**SUBJECT: Statutory Public Meeting and recommendation – 420 Guelph Line official plan amendment and rezoning applications**

Report Number: PL-49-20

File Numbers: 505-01/20 and 520-02/20

Refuse the application for official plan and zoning by-law amendments submitted by Weston Consulting, on behalf of Valour Capital Inc. for the development of a 13-storey residential building on the property located at 420 Guelph Line.

**APPENDIX B**

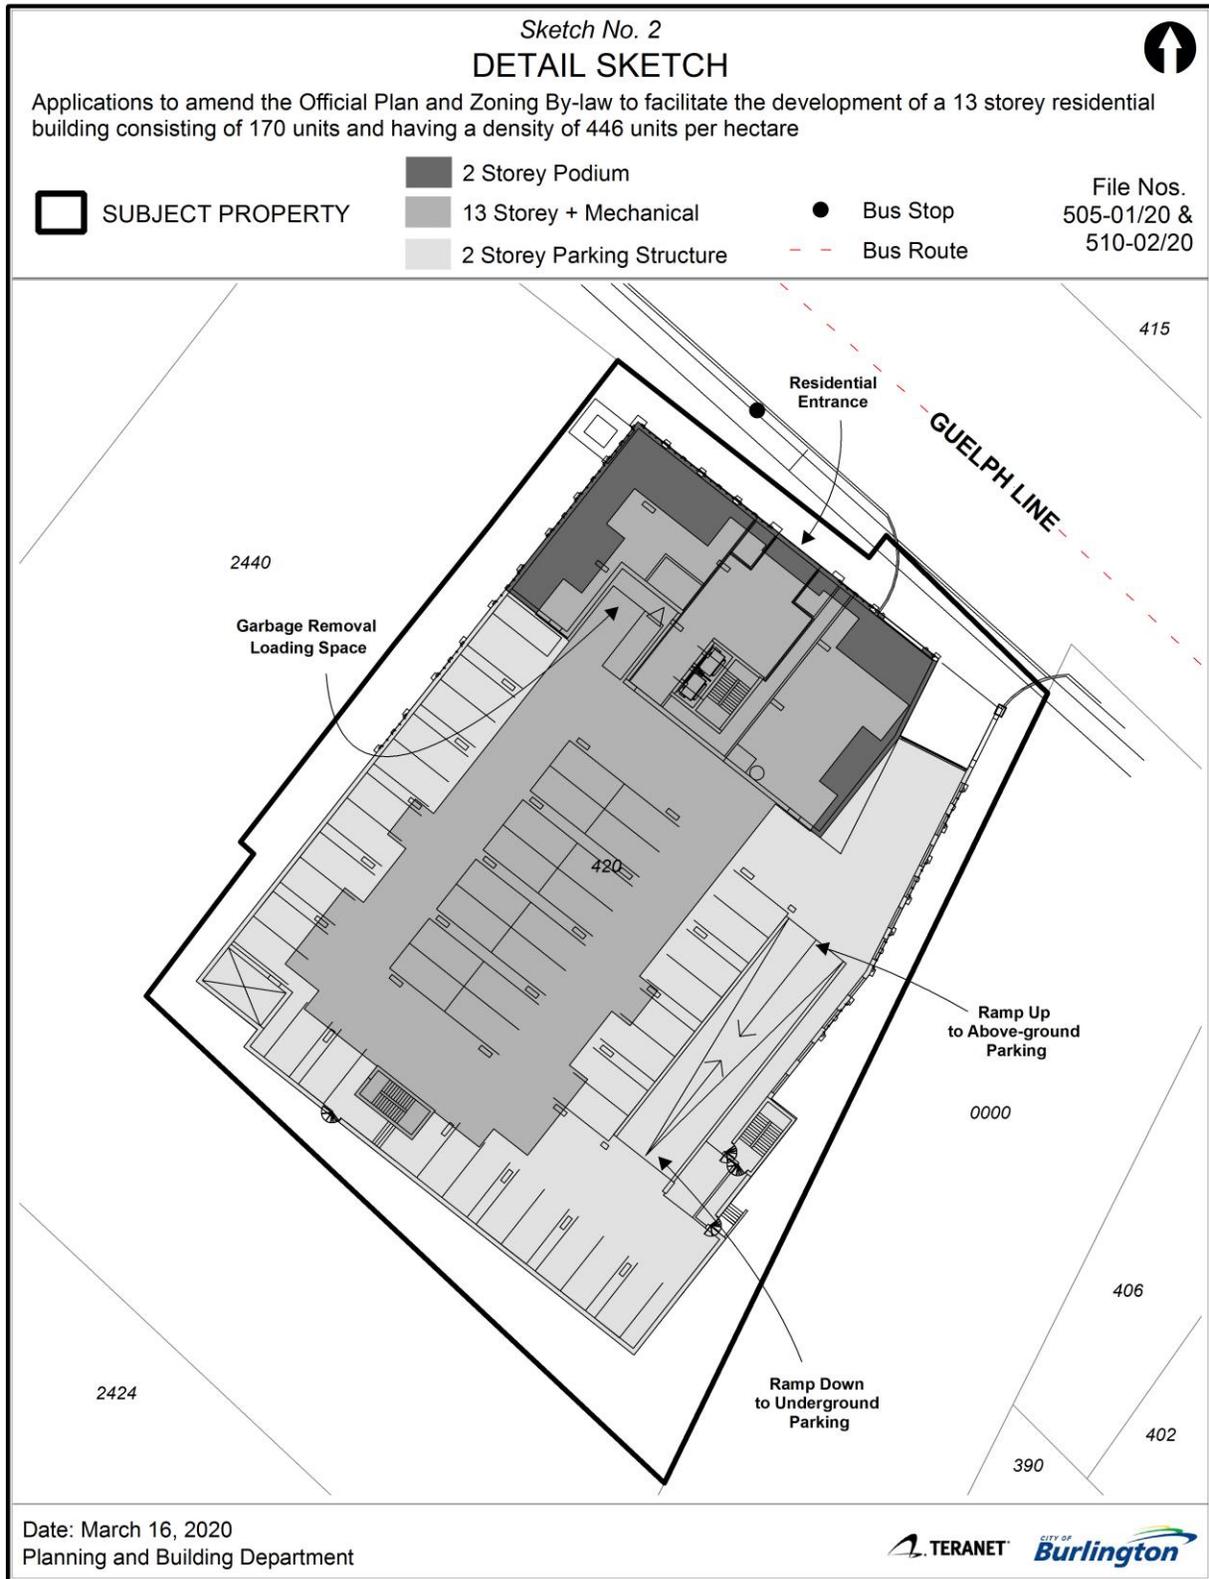
The applicant is proposing to rezone the lands to “Residential – High Density (RH4)”. This zone requires setbacks based on the building size and height. The front yard setback requirement is 7.5 metres plus 1 metre for each storey above 6 storeys. In this case, the minimum setback requirement would be 14.5 metres. The applicant is proposing a front

yard setback of 2.4 metres at the base of the building and 7.9 metres at the top of the building.

The side and rear yards for buildings greater than 30 metres are half of the building height plus an additional metre for each 5 metres that the building length exceeds 30 metres. It is not clear what the building length is; however, half the building height alone requires a 23 metre setback. The applicant is proposing rear and side yard setbacks of 2.6 metres at the closest point.

Staff are of the opinion that the proposed setbacks do not contribute to a development that is compatible with the surrounding area. The setback reductions may also impact the potential for future redevelopment of the lands to the north, which will be discussed further in this report. The setbacks should be increased to allow more space on the site to facilitate landscaping, screening, greenspace and to reduce the impact on nearby properties and the streetscape. This could be achieved by reducing the floorplate sizes which are not supported by staff and reducing the building mass.

The proposed lot coverage for the site is 74.1%. The site does not have space to accommodate commercial uses or outdoor amenity area at the ground level, which is currently to be used primarily for parking. To exacerbate this concern, the applicant is requesting reductions in development standards such as setbacks to accommodate an increased building size. Staff is of the opinion that the proposed building is too large for the site, and that the site layout is not appropriate. Reducing the size of the proposed building, the number of proposed units would also reduce the parking requirement would assist in achieving a more appropriate lot coverage.

As per the discussion of Official Plan Policy 2.5.2 a) ii) in this report, sufficient parking has been provided to support the proposed use. However, the proposed parking configuration is not appropriate on the site and the location of parking at the ground level and second storey is inappropriate given the Neighbourhood Commercial designation of the property. Active uses such as commercial/retail uses would be preferred at grade to activate and animate the streetscape. The proposal has exchanged conformity with a number of other objectives and regulations as outlined in this report in order to meet the parking requirement.

Staff are of the opinion that while the parking complies with the numerical requirement, it must be assessed within the context of the proposal as a whole and in this case, the location and layout is not appropriate.

Given the irregular shape of the lot, the setbacks range from 2.6 metres to 6.7 metres around the rear and side yards, with the majority of the building being set back less than 6 metres. While some trees are proposed to be planted along the perimeter of the subject lands, staff are not of the opinion that this is adequate to offset the impact of a 13 storey building given the considerations of Official Plan policy 2.5.2 a) v. While not immediately adjacent to low-density residential uses, there is an established low-density residential area to the southeast as well as many established low-rise retail and service commercial uses.

The applicant is proposing a north side yard setback of 2.6 metres for a building that is 13 storeys in height. In order to provide adequate separation between buildings and ensure proper screening, the property to the north would require additional setbacks on their side should they be redeveloped in the future. If a tall building were proposed on the lands to the north in the future, a separation distance of 25 metres between towers would be required. Increasing setbacks further in order to compensate for the reductions on the subject lands would limit the development potential of the property to the north.
